Access Compliance Report

Public Rights-of-Way

(Curb Ramps)

Intersection ID: 27323	Main Street: MEADOW_RUN_LN	Cross Street: THORNHILL_CLUB_DR	Location: SE
ADA ID: 63833986F3B6	Ramp Type: Perp	Initial Pass/Fail: Fail	Overall Compliance: No
		Severity Score: 35

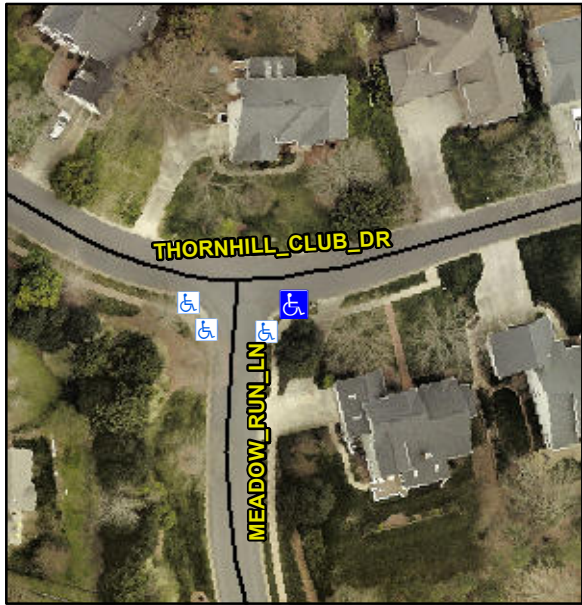
Codes/Mitigation Info/Possible Solution			Field Measurements/Component Compliance					
	Possible Solutions:		Compliance	Description	Data	Compliance	Description	Data
	Remove & Replace Entire Ramp.		N/A	Ramp Length (in)	116.0	Yes	Ramp Slope (%)	5.5
			No	Ramp Width (in)	28.0	Yes	Ramp XSlope (%)	1.2
			N/A	Flare Type LT	N/A	N/A	Flare Type RT	N/A
			N/A	Flare Slope LT (%)	N/A	N/A	Flare Slope RT (%)	N/A
			N/A	Flare Traversable LT?	N/A	N/A	Flare Traversable RT?	N/A
			N/A	Landing Length (in)	N/A	N/A	DWS Provided?	N/A
			N/A	Landing Width (in)	N/A	N/A	DWS Contrast?	N/A
			N/A	Landing Slope (%)	N/A	N/A	DWS Length (in)	N/A
			N/A	Landing X Slope (%)	N/A	N/A	DWS Full Width?	N/A
Surveyor Notes:			N/A	Landing Curb? (Y/N)	N/A	N/A	DWS Offset (in)	N/A
PROW/ADA:			N/A	Shared Landing?	N/A			
Not Found, R304.5.1			N/A	Gutter Ponding?	N/A	N/A	Gutter Slope (%)	N/A
			N/A	Gutter Lip Ht (in)	N/A	N/A	Gutter X Slope (%)	N/A
			N/A	Painted X Walk1?	No	N/A	Painted X Walk2?	N/A

X Walk 1 Direction	To N		X Walk 2 Direction	N/A
			N/A	X Walk 1 Width (in)	N/A	N/A	X Walk 2 Width (in)	N/A
				X Walk 1 Slope (%)	3.2		X Walk 2 Slope (%)	N/A
				X Walk 1 X Slope (%)	3.7		X Walk 2 X Slope (%)	N/A
			N/A	Ramp inside XWalk1?	N/A	N/A	Ramp inside XWalk2?	N/A
				Road Slope (%)	N/A	N/A	Clear Space?	N/A
				Road X Slope (%)	N/A	N/A	Clear Space to XWalk (in)	N/A
			N/A	Any Obstructions?	N/A	N/A	Storm Grate/Utility Hazard?	N/A
				Obstruction Type			Storm Grate/Utility Type	
					N/A			N/A
						Yes	Surface Condition? (G/P)	Good
Total Cost:		\$ 1850.00
